ADDENDUM NO. 5

City of Springfield CITY COMPLEX

Mott MacDonald Project No.: 502100062

September 12, 2024

SHEET NUMBER:
C1.4

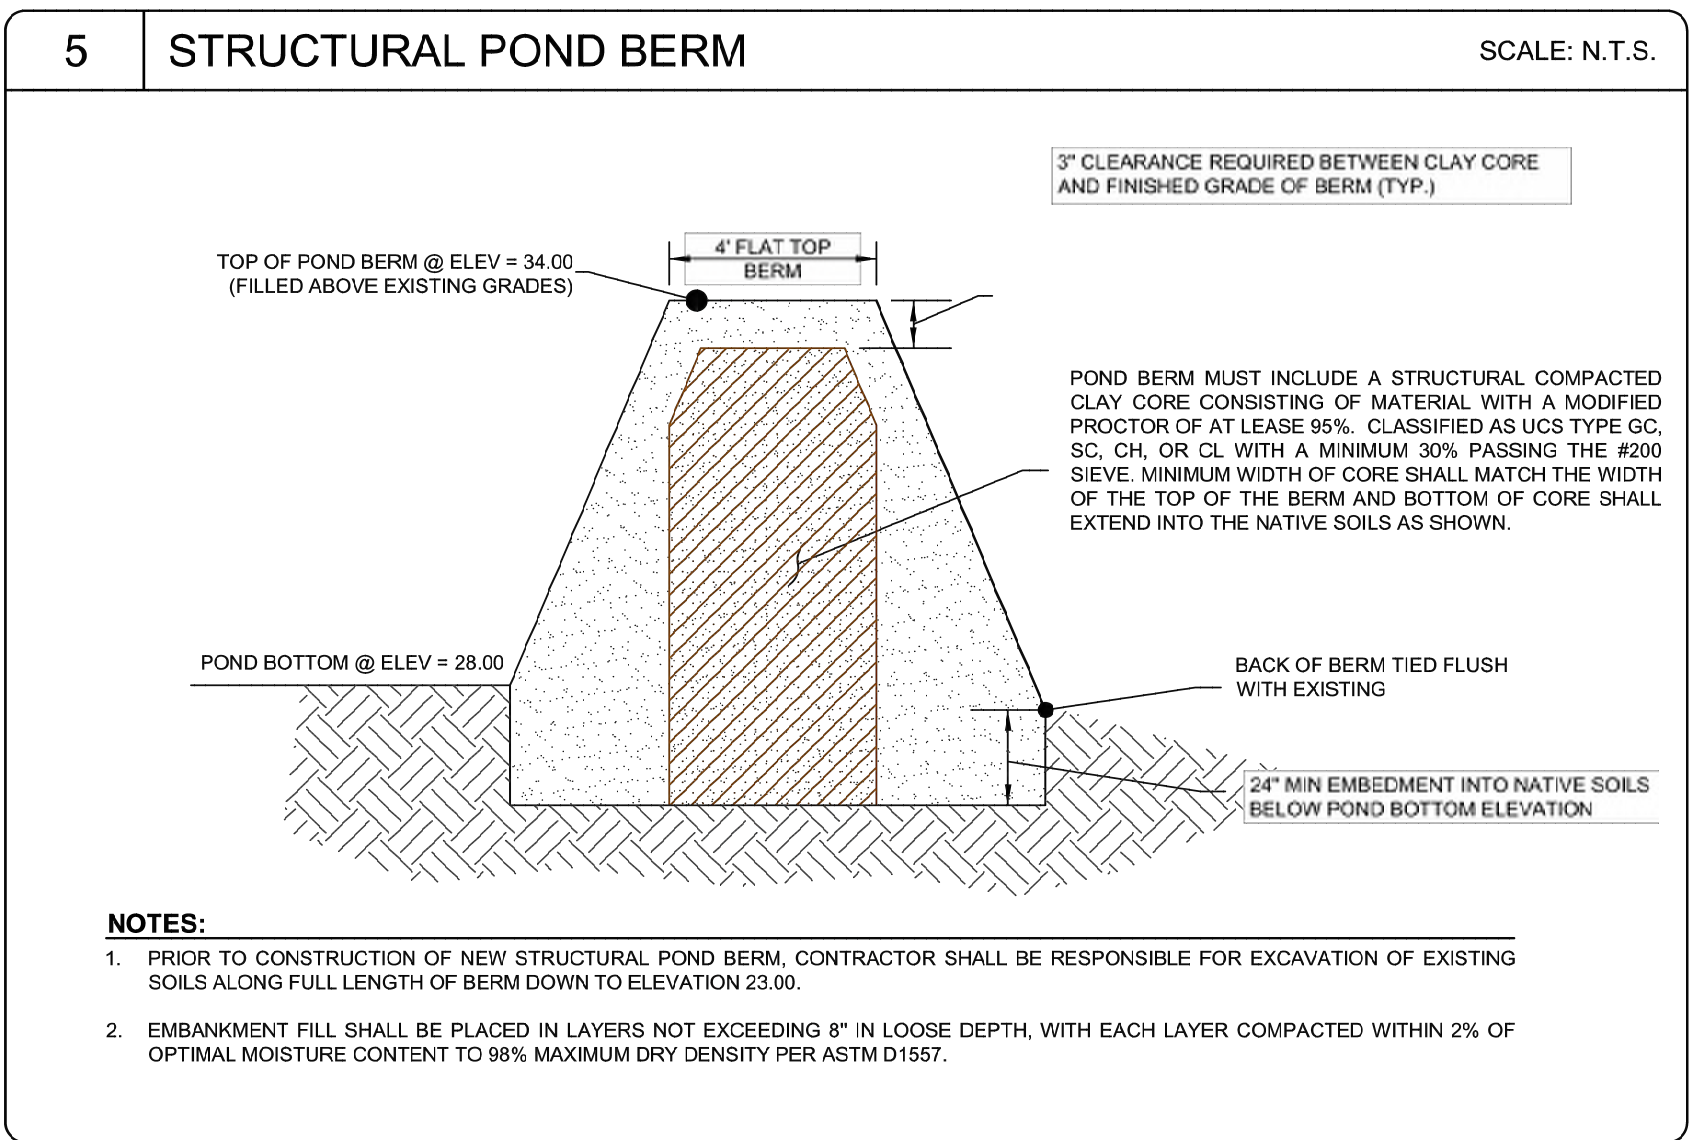
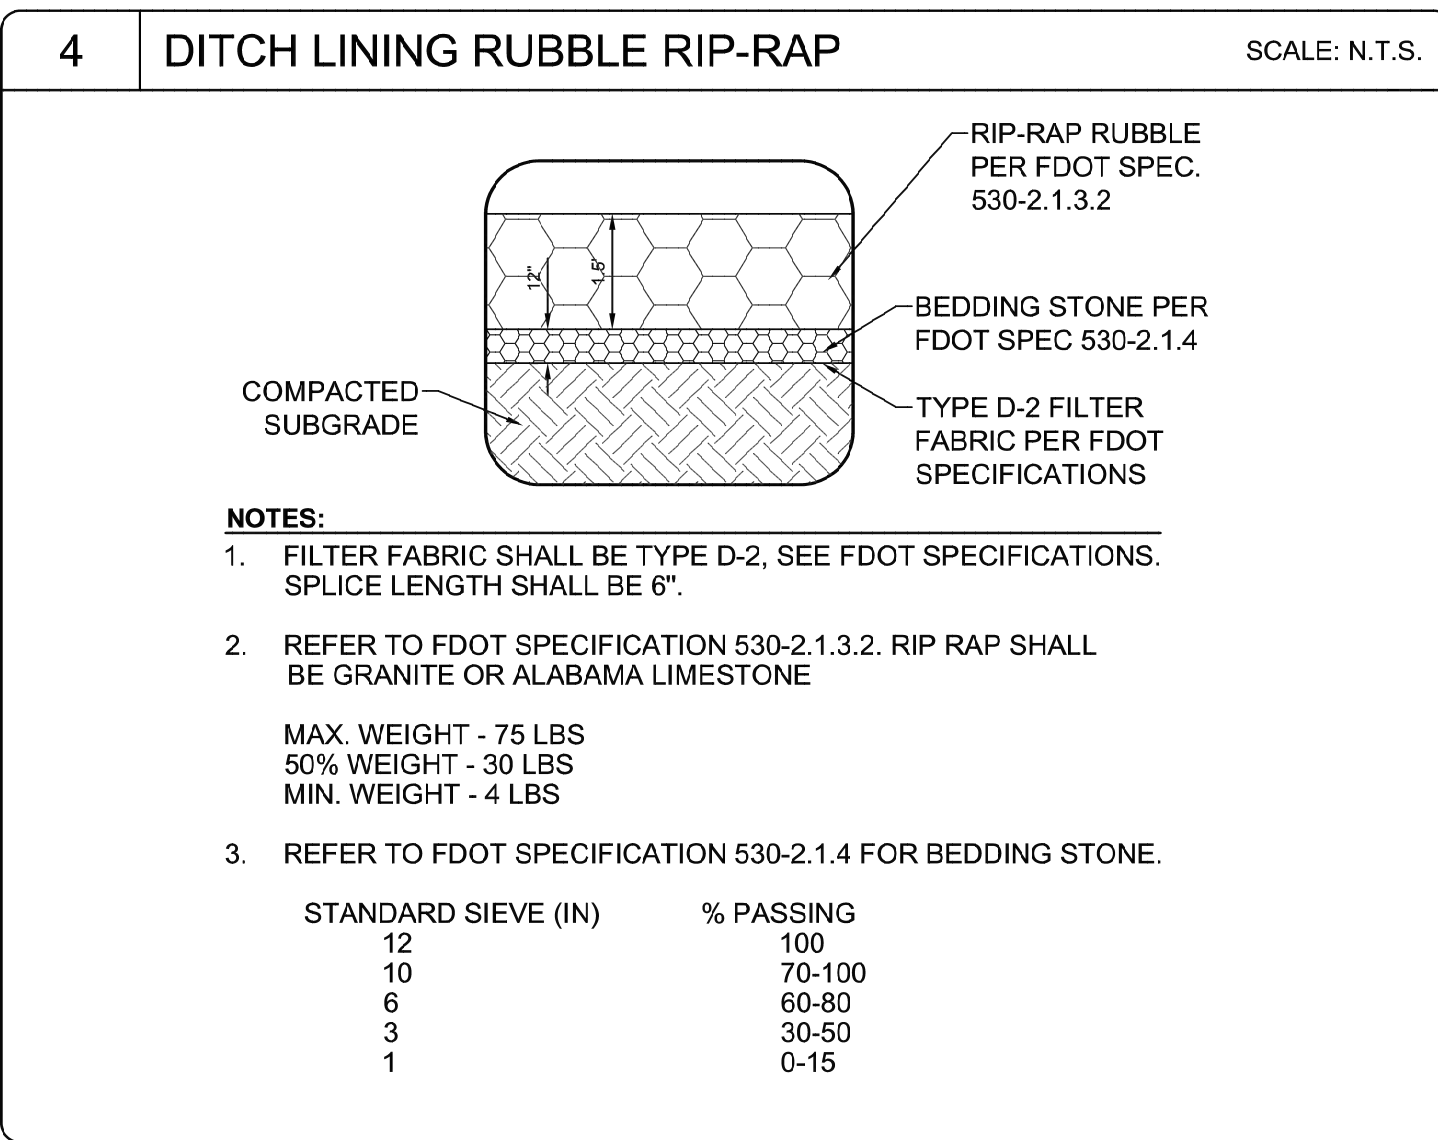
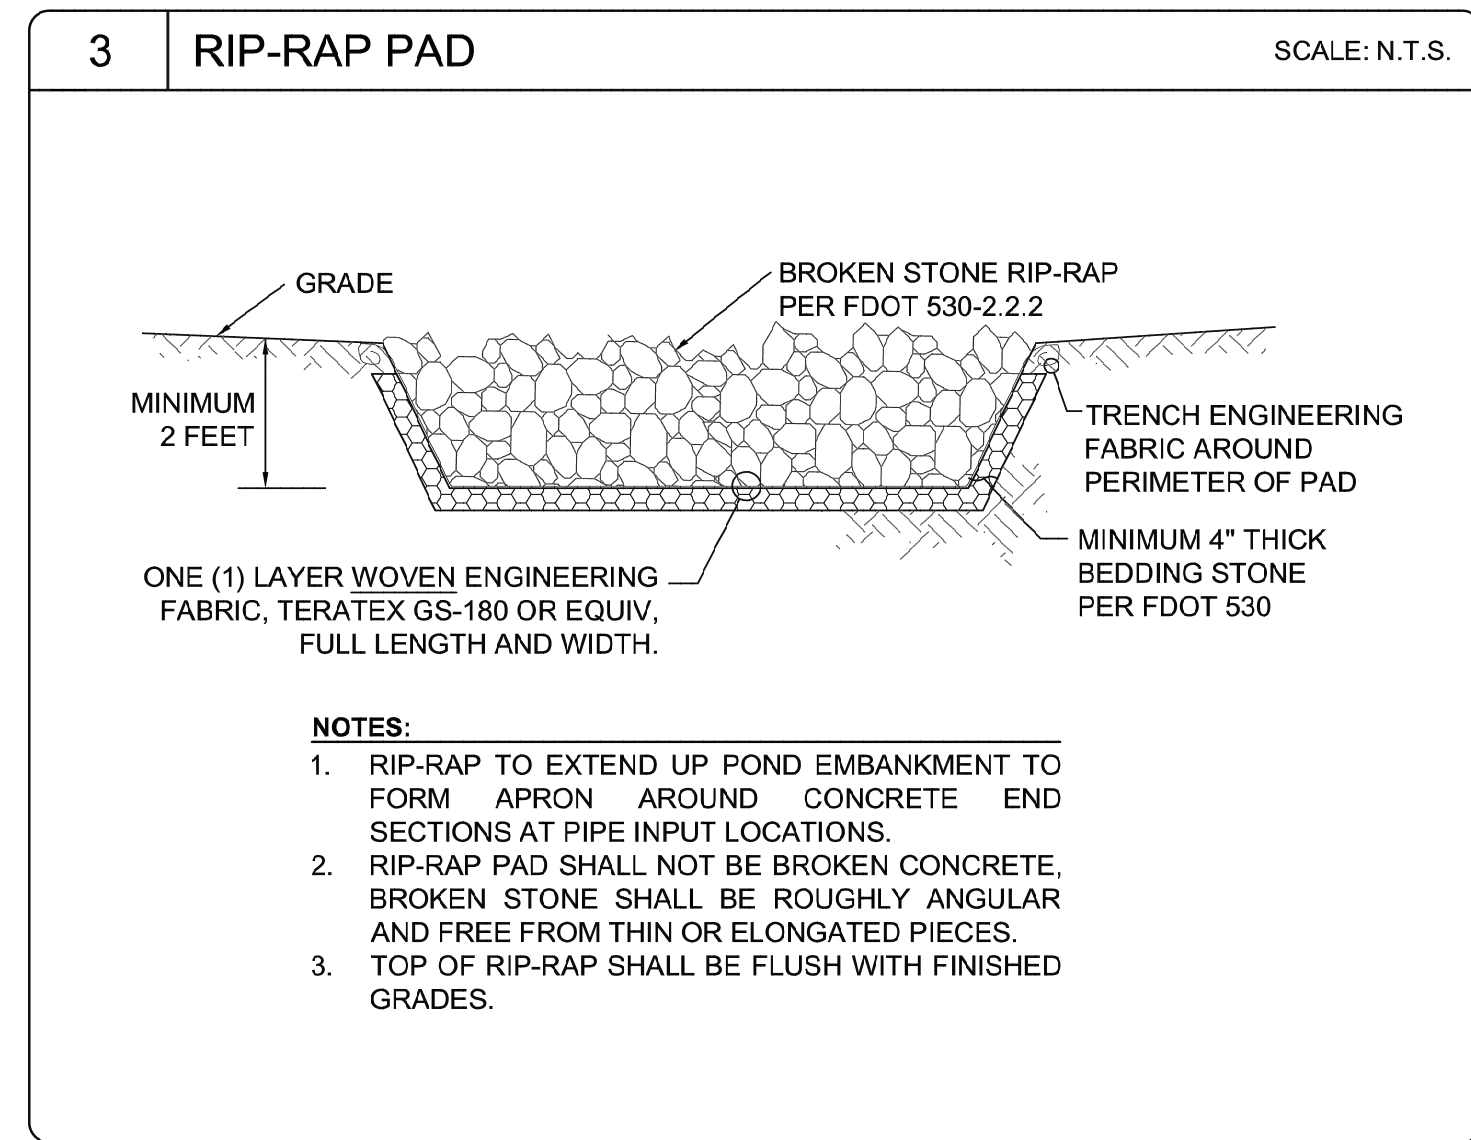
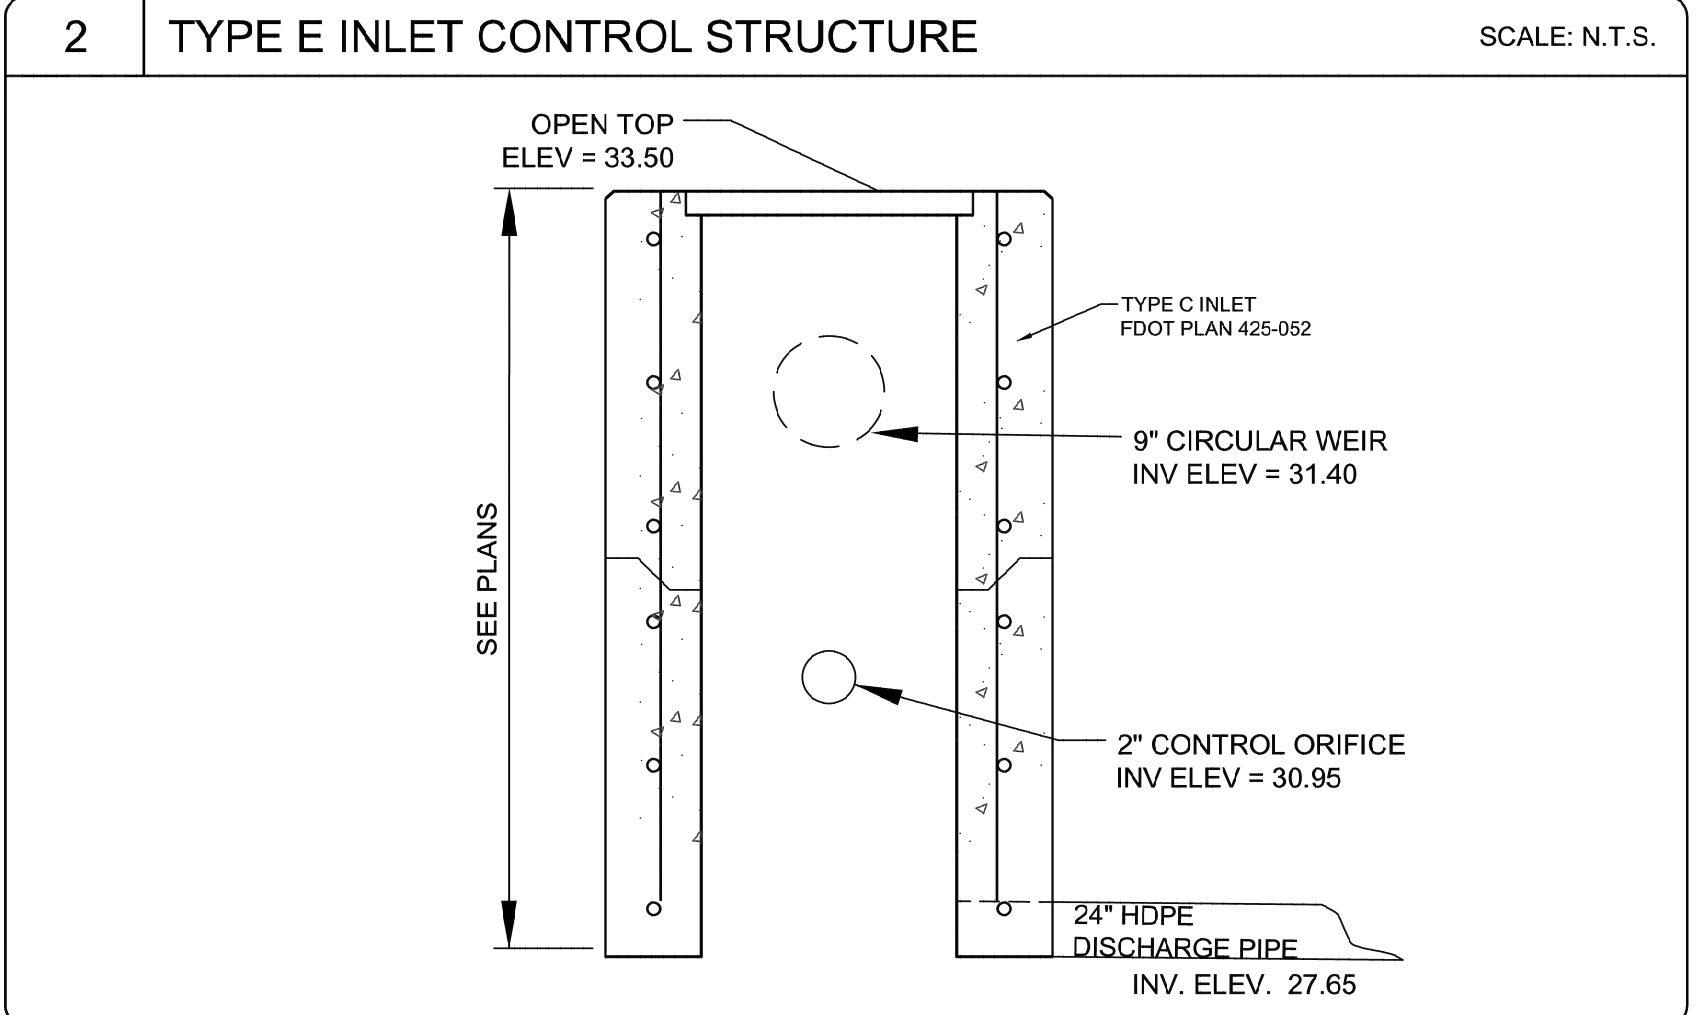
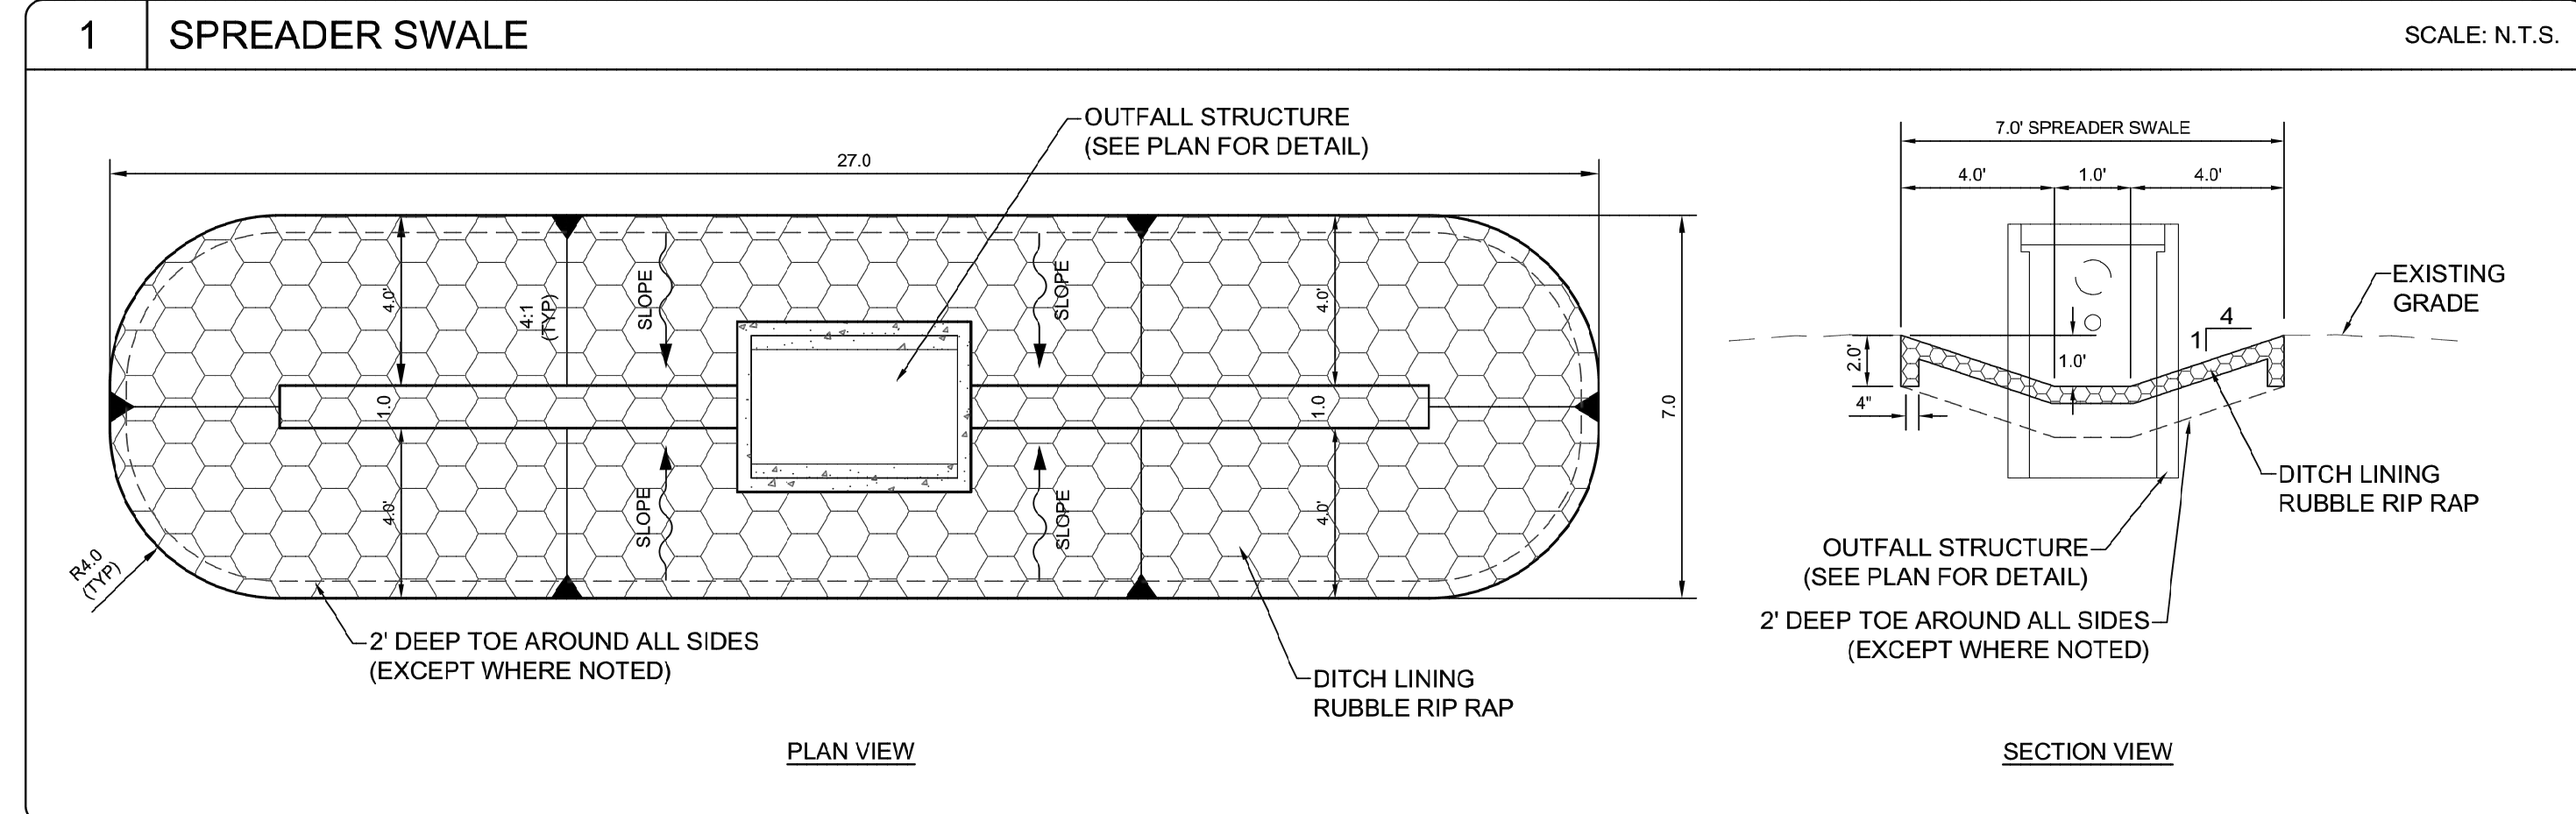
- 1. Sheet C1.3 has been revised by the addition of earthwork volumes and related notes and is attached to this Addendum No. 5 as C1.3 Rev.
- 2. New Plan Sheet C1.4 "Grading Details" which provides details of the stormwater pond is hereby added and is attached to this Addendum No. 5.

98. QUESTION: On sheet C 1.3/C-301 it states Clay-Core berm on the lower part of the pond, can we get a detail and limits of the Clay- Core berm? Also on the same sheet it's showing a Spreader swale at the outfall discharge, can a detail be provided for the spreader swale? RESPONSE: A revised Sheet 1.3 Rev. and a new Sheet 1.4 have been added and are attached to Addendum #5 to which these questions are also attached.

- NOTES:**
- PONDS MUST BE SUBSTANTIALLY COMPLETE PRIOR TO ANY CONSTRUCTION ACTIVITIES THAT MAY INCREASE STORM WATER RUNOFF RATES. THE CONTRACTOR MUST CONTROL STORM WATER DURING ALL PHASES OF CONSTRUCTION AND TAKE ADEQUATE MEASURES TO PREVENT THE EXCAVATED POND FROM BLINDING DUE TO SEDIMENTS.
 - SIDE SLOPES SHOULD BE STABILIZED TO THE PERMANENT POOL ELEVATION.
 - UPON FINAL COMPLETION OF CONSTRUCTION AND STABILIZATION OF ALL UPSTREAM AREAS, POND MUST BE RE-SHAPED AS NECESSARY TO REMOVE ACCUMULATED SEDIMENT AND TO MATCH THE PROPOSED GRADING ON THE PLANS. ALL DISTURBED AREAS MUST BE RE-STABILIZED AND SODDED.
 - POND MUST BE DESIGNED SO THAT THE POND SIDE SLOPE MEASURED BETWEEN THE CONTROL ELEVATION AND TWO FEET BELOW THE CONTROL ELEVATION IS NO STEEPER THAN 4H:1V.
